THE VILLAS AT CLAREMONT RANCH

STREET IMPROVEMENTS PLANS

THE VILLAS AT CLAREMONT RANCH

STORM SEWER PLANS

DRAWN BY: MGP	DATE: 01/17/20
SCALE: 1" = 50'	JOB NUMBER: SHEET
16-102	4 OF 6

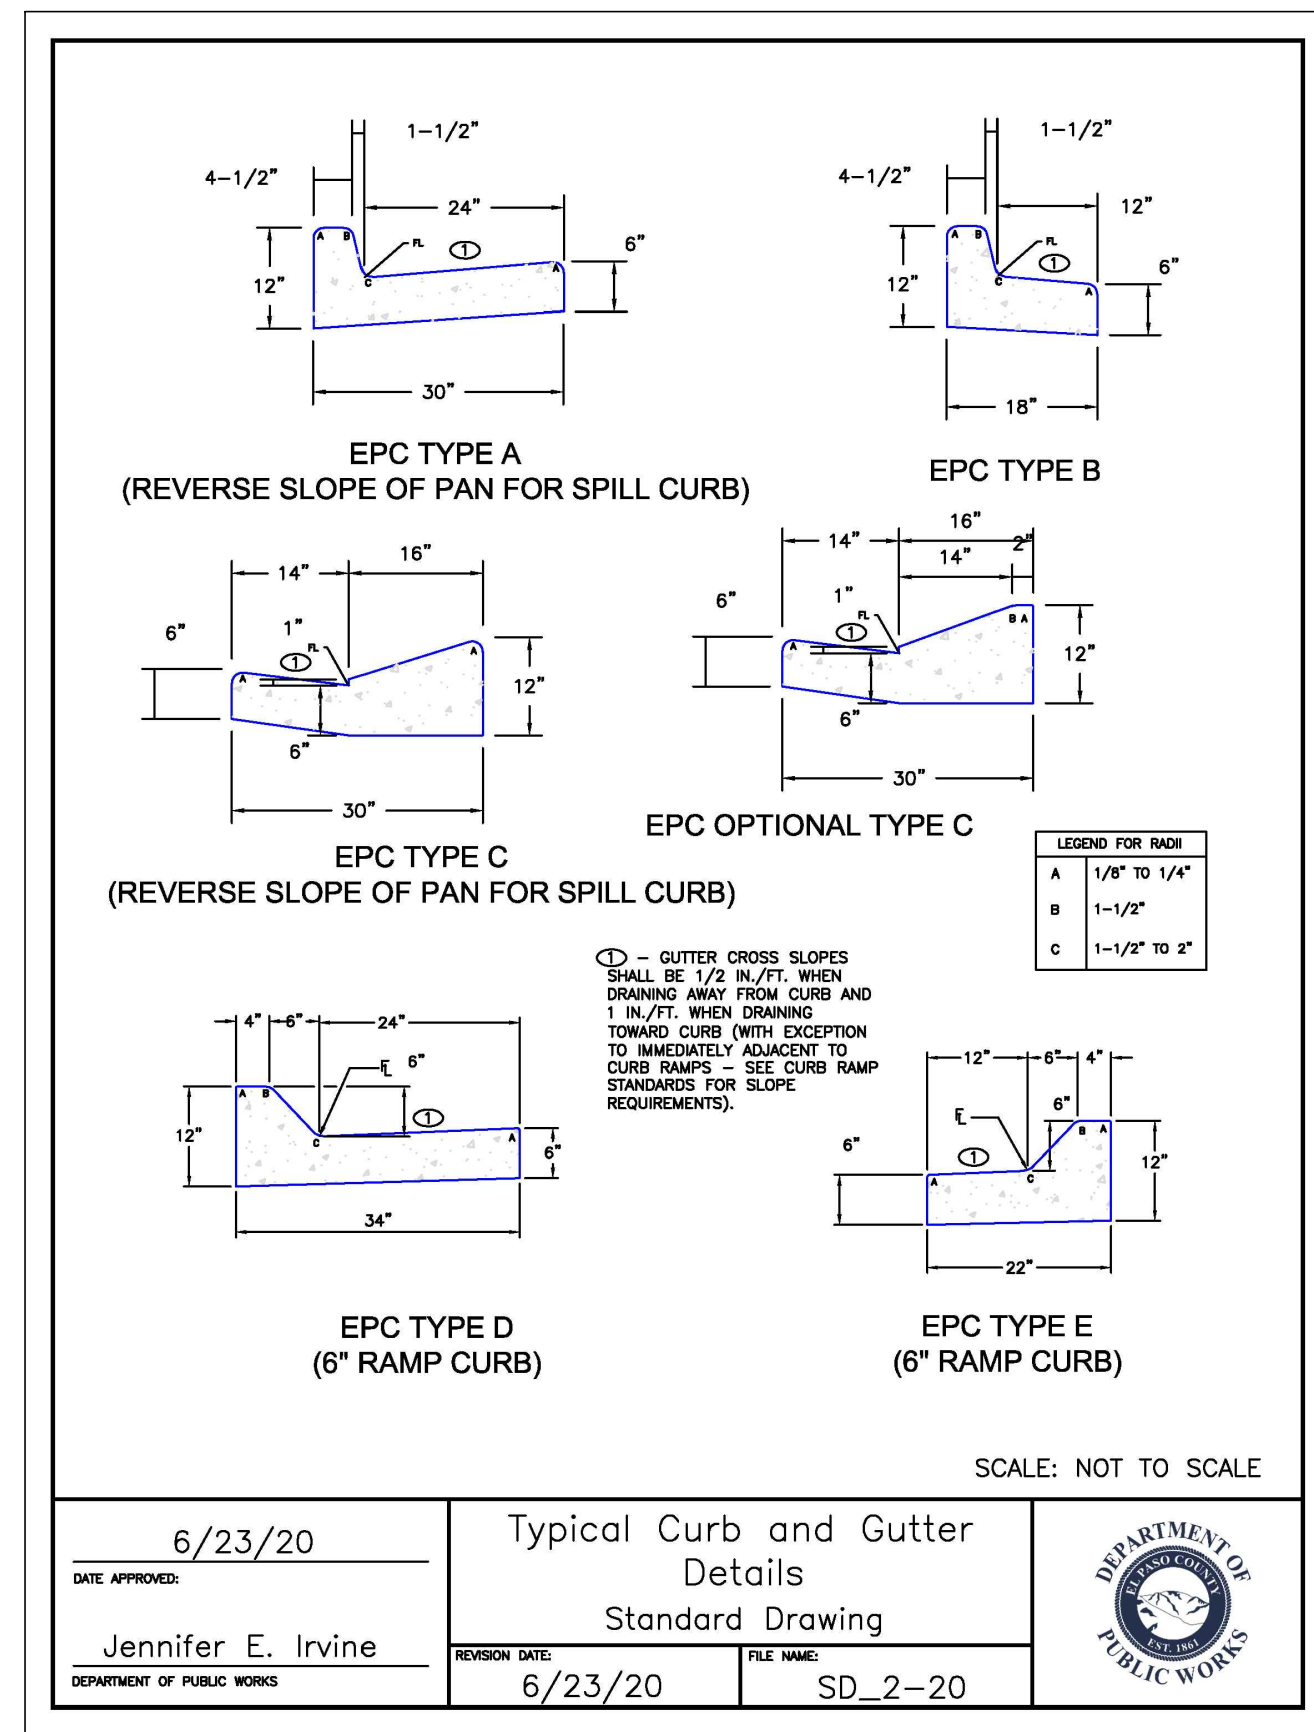
Add curb transition detail

THE VILLAS AT CLAREMONT RANCH
STORM SEWER PLAN & PROFILES

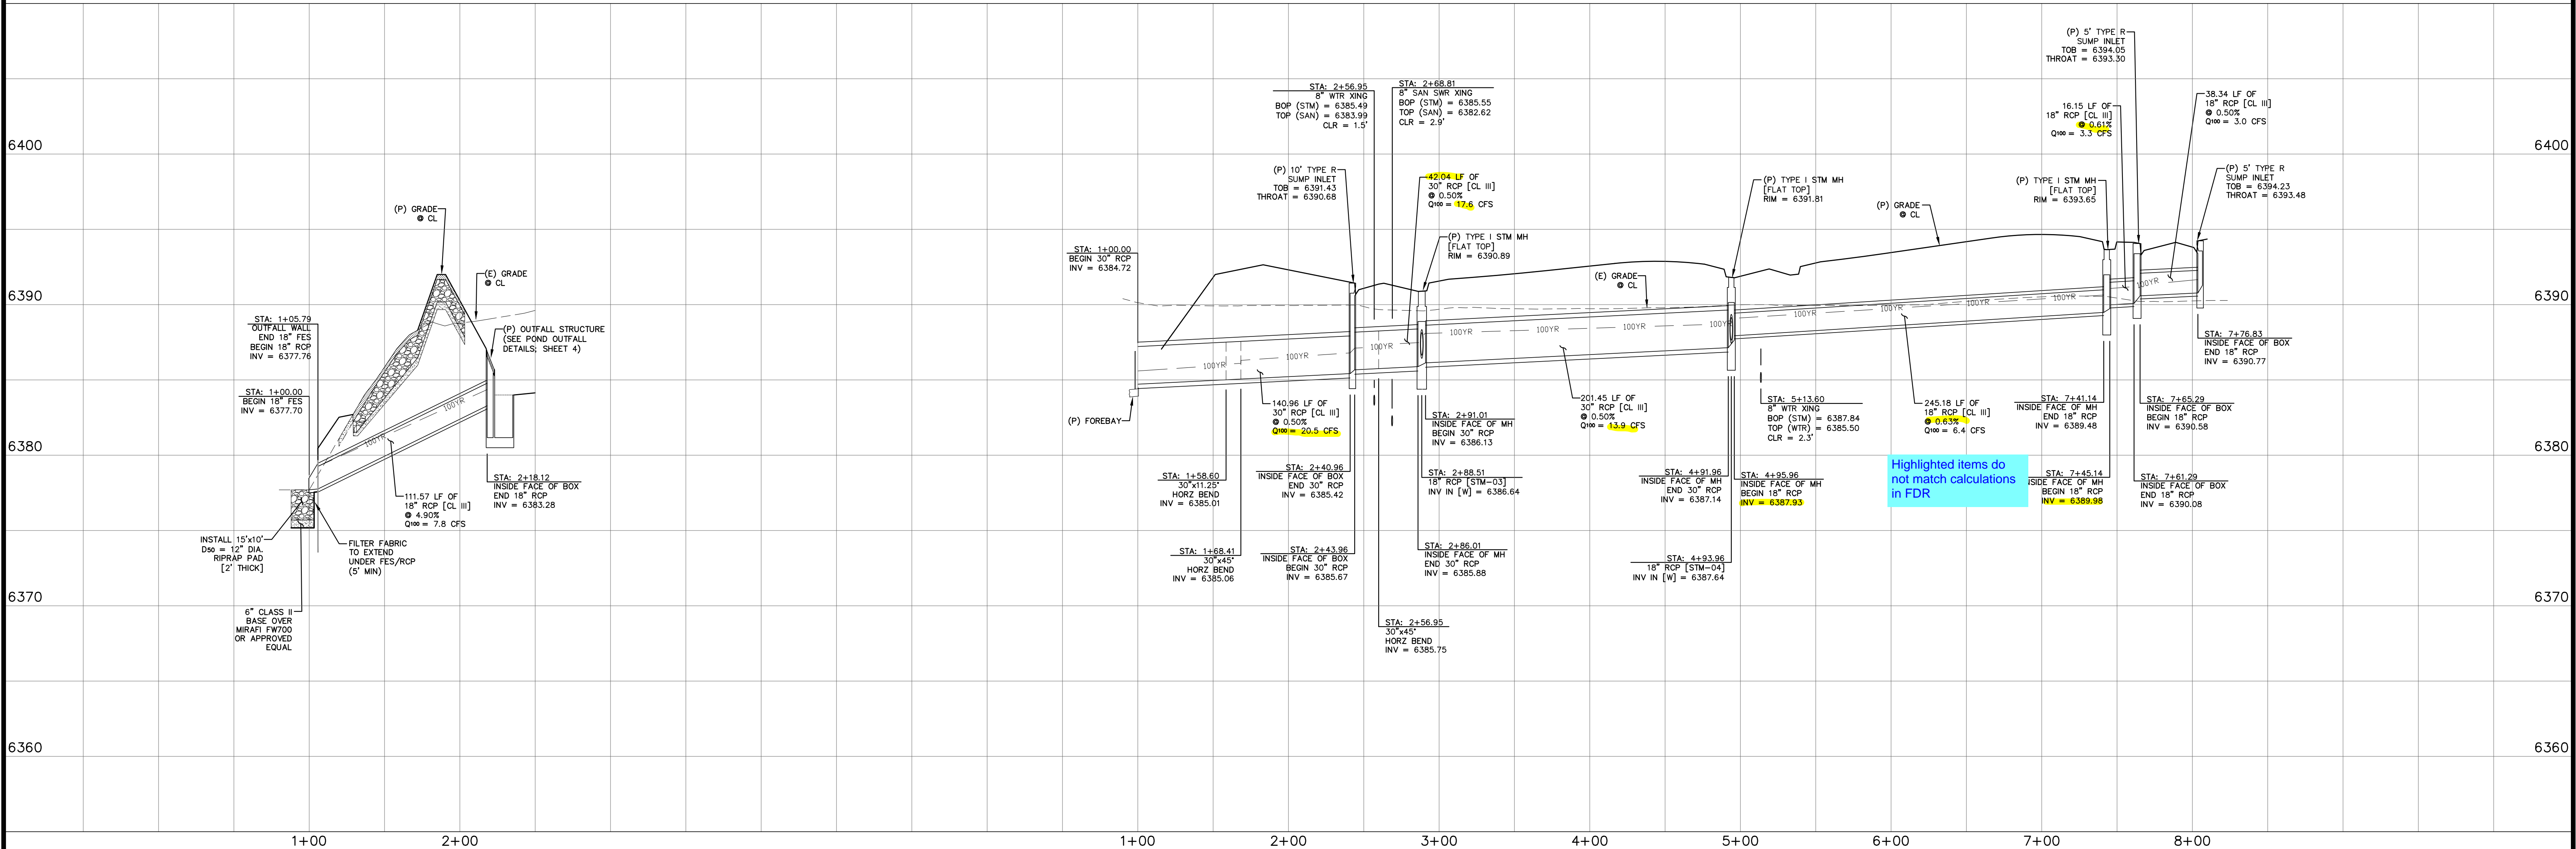
Highlighted items do not match calculations in FDR
